UNITED STATES PATENT AND TRADEMARK OFFICE

APPLICATION NO.	FILING DATE	FIRST NAMED INVENTOR	ATTORNEY DOCKET NO.	CONFIRMATION NO.
10/672,355	09/29/2003	Edward R. Newton	1898-4	3010

Office Action Summary

DETAILED ACTION

Exhibit A

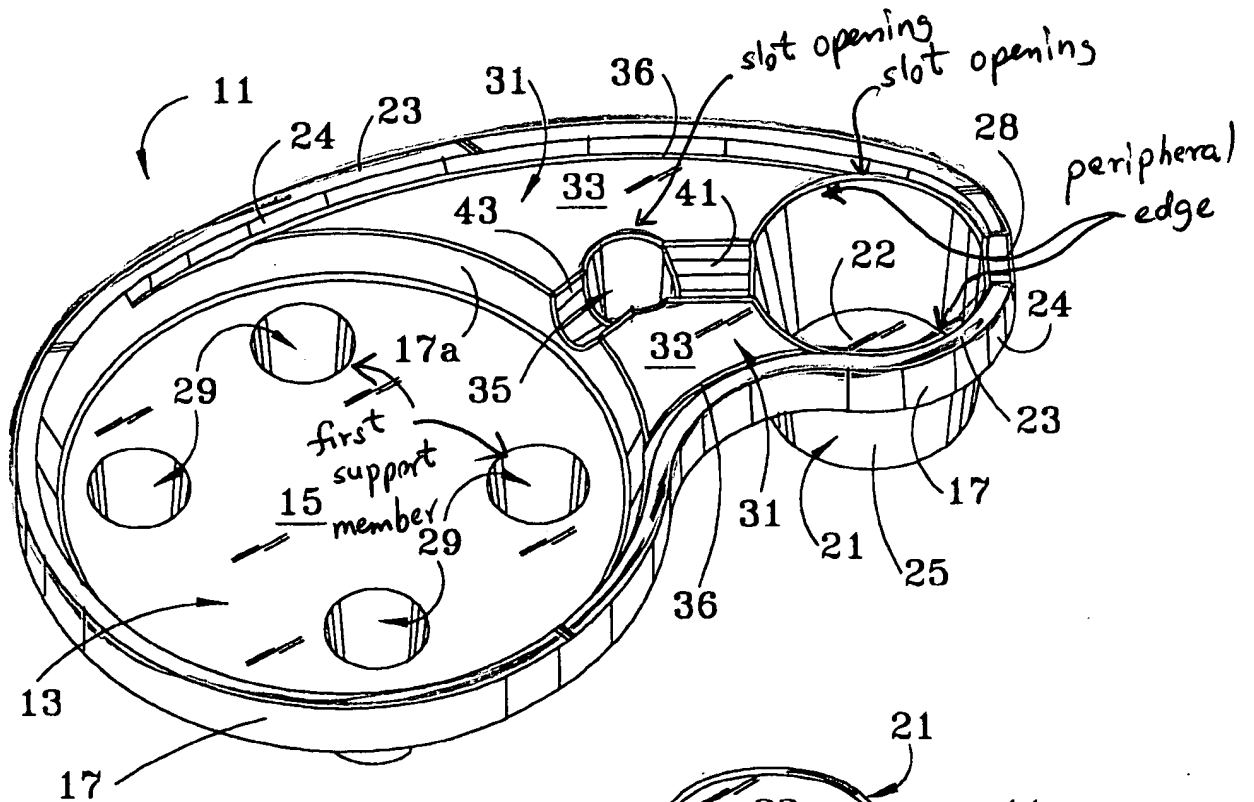
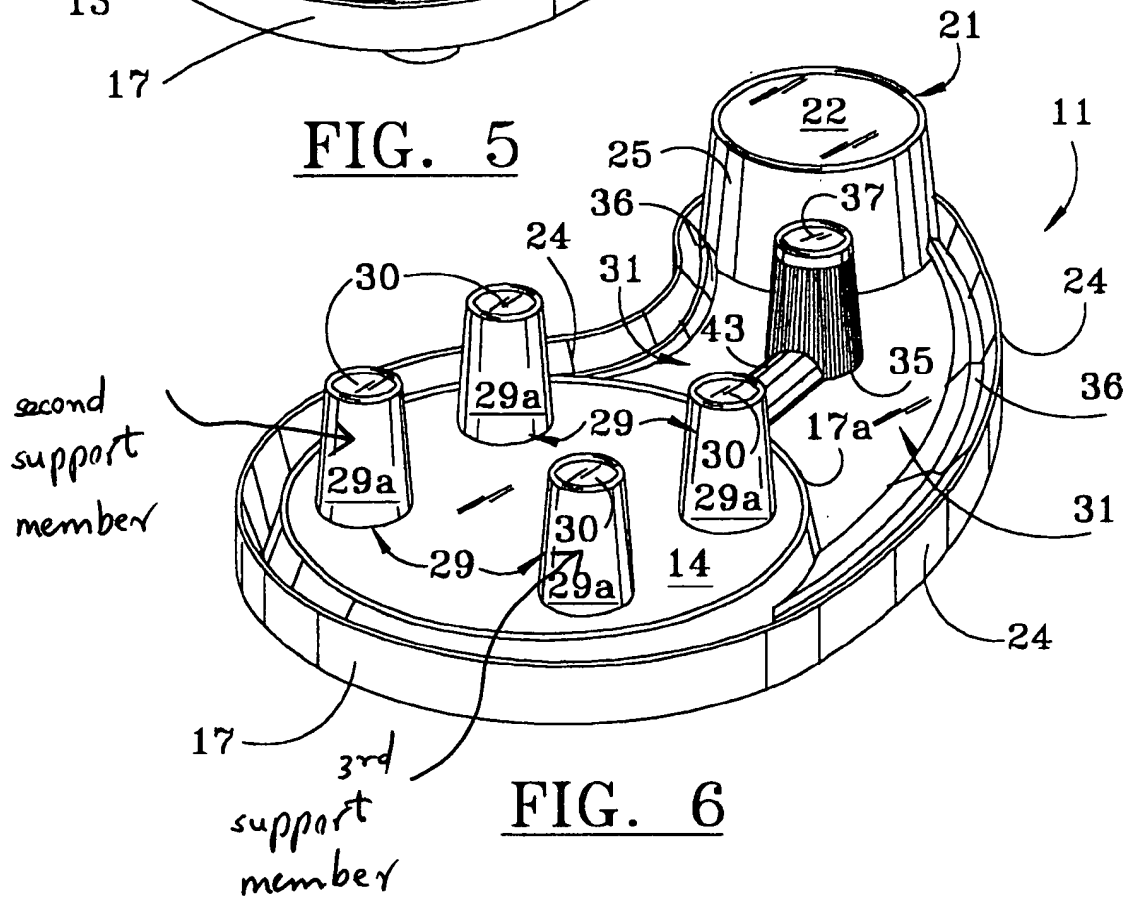
6. Claim 25, as best understood, is rejected under 35 U.S.C. 102(b) as being anticipated by Bradley (6,264,026).

Bradley (6,264,026) discloses a beverage holder (see Exhibit A) comprising a panel (15,33) having a peripheral edge (see Exhibit A), the panel having a plurality of slots openings at the peripheral edge, each of the plurality of slots extending from the peripheral edge (see Exhibit A), the panel having a top surface and a bottom surface, a support element extending downwardly from the bottom surface (15) of the panel (see Figs. 5 and 6), the support element comprising a first support member (29) (Figs. 5 and 6) extending downwardly from a central area, a second support member, and a third support member, wherein the each support member being tapered (Fig. 6) having a wide diameter at the bottom surface (Fig. 5) and a narrow diameter at the bottom (30) of the support member (see Fig. 6), and the bottom ends (30) of the support members are coplanar with each other and in parallel planar in relation with the panel (15) (lines 47-65 of Col 6).

Exhibit B

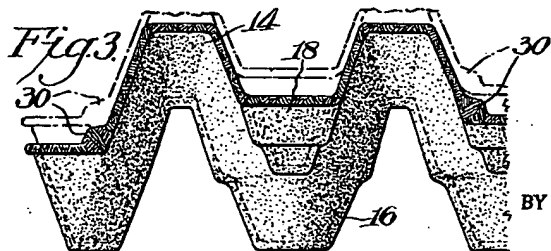
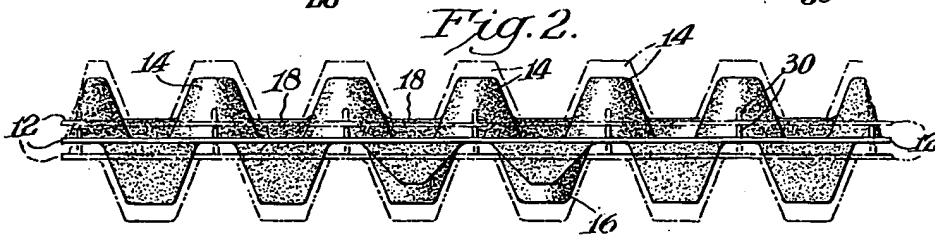
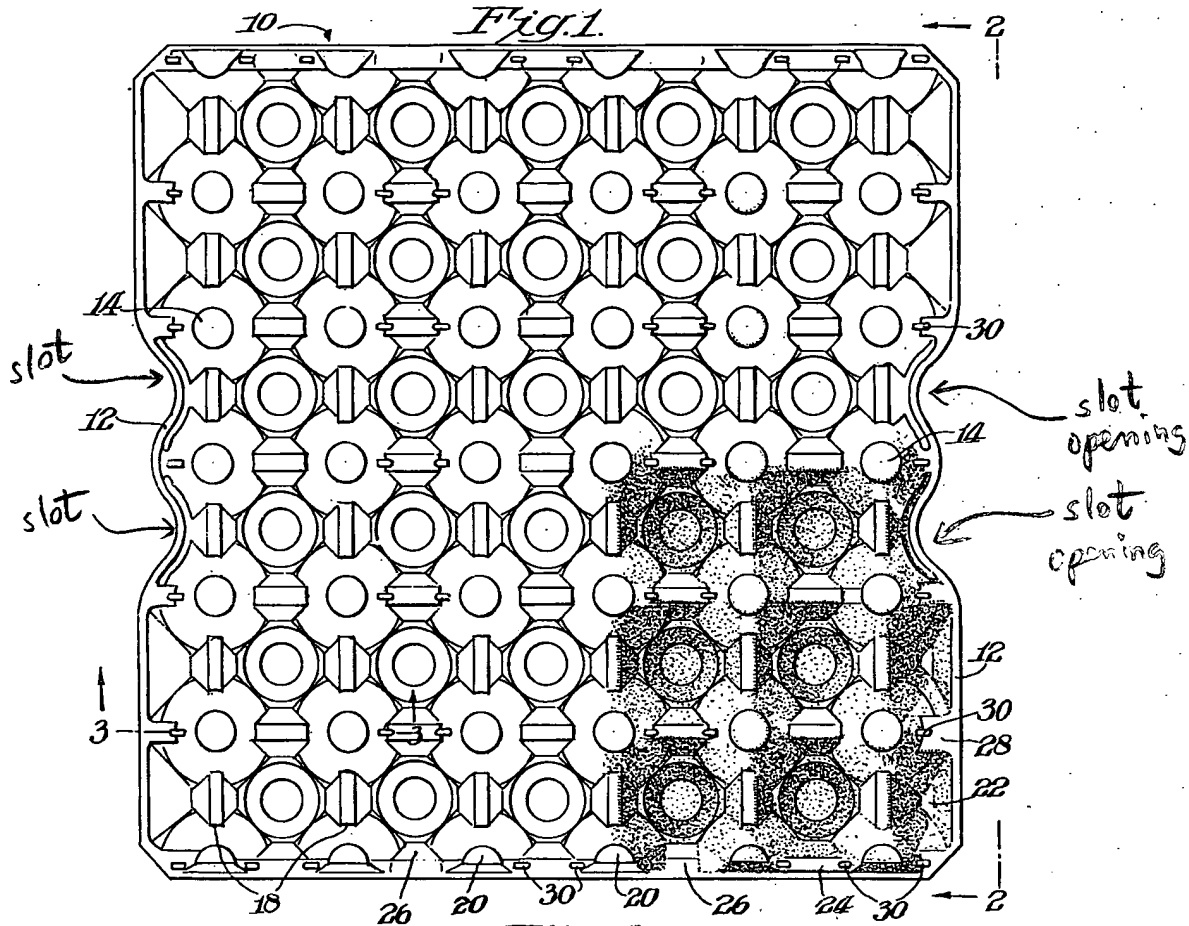
7. Claim 25, as best understood, is rejected under 35 U.S.C. 102(b) as being anticipated by Emery (2,997,196).

Emery (2,997,196) discloses a beverage holder (see Exhibit B) comprising a panel (Fig. 1) having a peripheral edge (12) (see Exhibit B), the panel having a plurality of slots openings at the peripheral edge, each of the plurality of slots extending from the peripheral edge (see Exhibit B), the panel having a top surface and a bottom surface, a support element extending downwardly from the bottom surface (Fig. 2) of the panel, the support element comprising a first support member (16) extending downwardly from a central area, a second support member (16), and a third support member (16), wherein each support member being tapered (Figs. 2 and 3) having a wide diameter at the bottom surface and a narrow diameter at the bottom of the support member (see Figs. 2

and 3), and the bottom ends of the support members are coplanar with each other and in parallel planar in relation with the panel (see Figs. 2 and 3).
